City of San Antonio

Re: Westwinds (Alamo Ranch)

MDP # 808-F Amending 808-B

WESTWINDS (ALAMO RANCH)
MASTER DEVELOPMENT PLAN 808-F
AMENDING 808-B

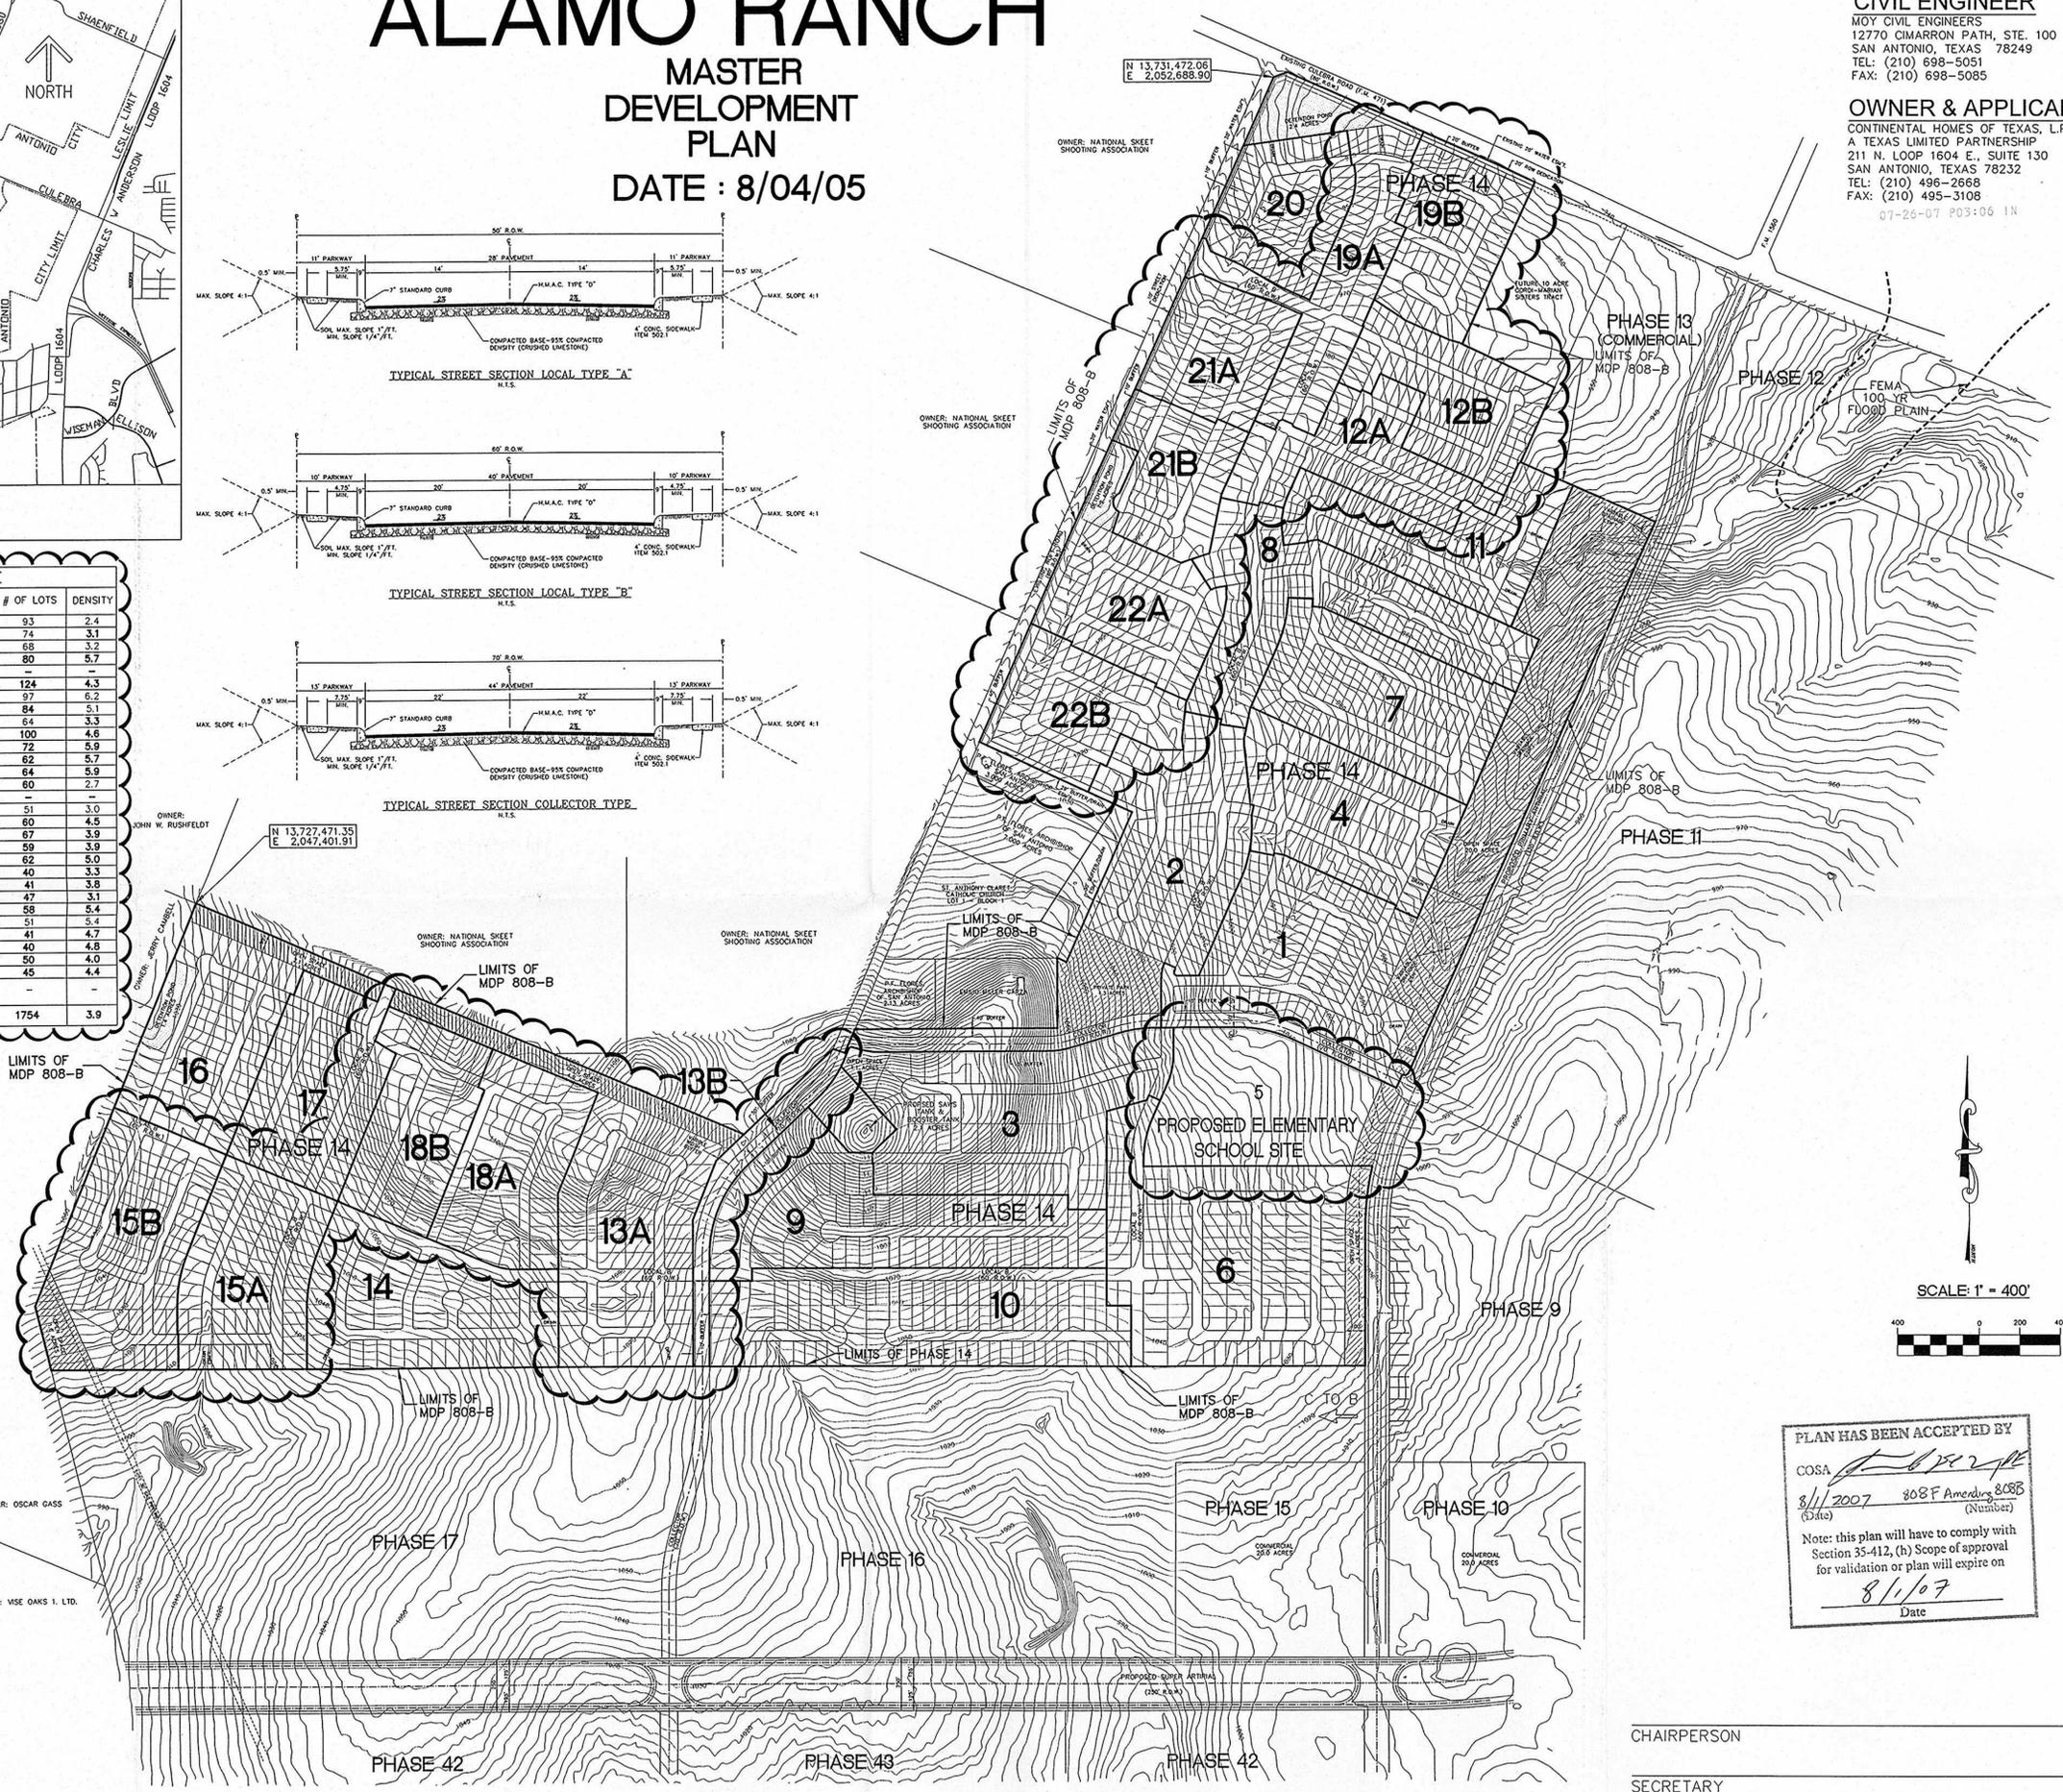
In consideration of public safety and convenience, excessive grades by reason of topography should be avoided in street layouts and arrangements. Any access and right-of-way issues along state facilities will need to be resolved with the **Texas Department of Transportation (TXDOT)**. For information about these requirements you can contact TXDOT at (210) 615-5814.

- All access roadways shall provide clear sight distance on all existing and proposed roadways in order to provide adequate obstruction free viewing distances for approaching traffic. All signage, landscaping, and improvements shall be selected and located so as to not block these clear sight distance areas.
- Sidewalks along all interior and exterior roadways are to be installed in accordance with UDC 35-506(q).
- The east-west collector shall be stripped two lanes and a two-way left turn lane in accordance with the submitted plan 10-27-05.
- Pavement widening for Roft Road (labeled Street "F" on MDP #808 with 70 feet of right of way) requires two northbound lanes, a minimum pavement width of twenty-two feet from the centerline of the right of way, curb and sidewalk.

- The following three intersections will require mitigation for traffic signals when warranted and approved by Bexar County Traffic, Public Works – Traffic and TXDOT as per UDC §35-502, (a)(7)C. Lane configuration of all intersections shall follow Table 14 as amended January 27, 2005 in the Level 3 Traffic Impact Analysis:
 1. East west collector (labeled Street "G" on MDP #808 with 70 feet of right of way) and Alamo Parkway (120 feet of right of way)
 2. FM 1560 (Alamo Parkway) and FM 471
 3. FM 471 and Roft Road (labeled Street "F" on MDP #808 with 70 feet of right of way)

All platting shall comply with the Unified Development Code (UDC), Master Plan, and Major Thoroughfare Plan for the City of San Antonio. It will be expected that all of the property depicted in your Master Development Plan to include floodplains, drainage areas, and open space shall be platted. It is suggested to work closely with the school district, so they can plan accordingly.
